UNITED STATES PATENT AND TRADEMARK OFFICE

APPLICATION NO.	FILING DATE	FIRST NAMED INVENTOR	ATTORNEY DOCKET NO.	CONFIRMATION NO.
10/817,531	04/02/2004	Marc Schaepkens	133525-1/YOD GERD:0065	4869
7590 07/21/2005			EXAMINER	
Patrick S. Yoder FLETCHER YODER P.O. Box 692289 Houston, TX 77269-2289			WILSON, ALLAN R	
			ART UNIT	PAPER NUMBER
			2815

Office Action Summary	Application No. 10/817,531	Applicant(s) SCHAEPKENS ET AL.	
	Examiner Allan R. Wilson	Art Unit 2815

DETAILED ACTION

The following copy of Kumar's Fig. 2 will be used for rejection of claims 3-5:

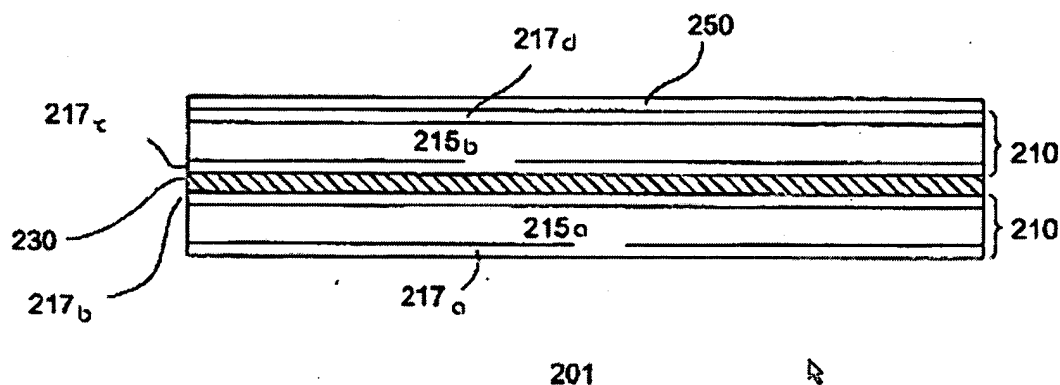
With regards to claim 2, Kumar illustrates in Fig. 2 the flexible substrate 201 comprises the barrier coating 217.

With regards to claim 3, the above fig. illustrates a first protective layer 217_a configured to resist abrasion ; a polymeric transparent film 215 coupled to the first protective layer; a barrier coating 217_c coupled to the transparent film; and a second protective layer 217_d coupled to the barrier coating and configured to protect the transparent film from chemical attack during fabrication.

The limitations “resist abrasion” and “protect the transparent film from chemical attack during fabrication” is an inherent function of the material. Kumar discloses in col. 2, lines 38-

41, the barriers are metal oxide, silicon oxide or nitrides; which are abrasion and chemical resistant.

With regards to claim 4, the above fig. illustrates a first protective layer 217_a configured to resist abrasion; a first polymeric transparent film 215a coupled to the first protective layer; a first barrier coating 217_b coupled to the first transparent film; a second barrier coating 217_c coupled to the first barrier coating via an adhesive layer 230; a second polymeric transparent film 215b coupled to the second barrier coating; and a second protective layer 217_d coupled to the barrier coating and configured to protect the transparent film from chemical attack during fabrication.

With regards to claim 5, the above fig. and Fig. 5 illustrates a barrier coating 217_d coupled between the flexible substrate 201a and the organic electronic device 560.
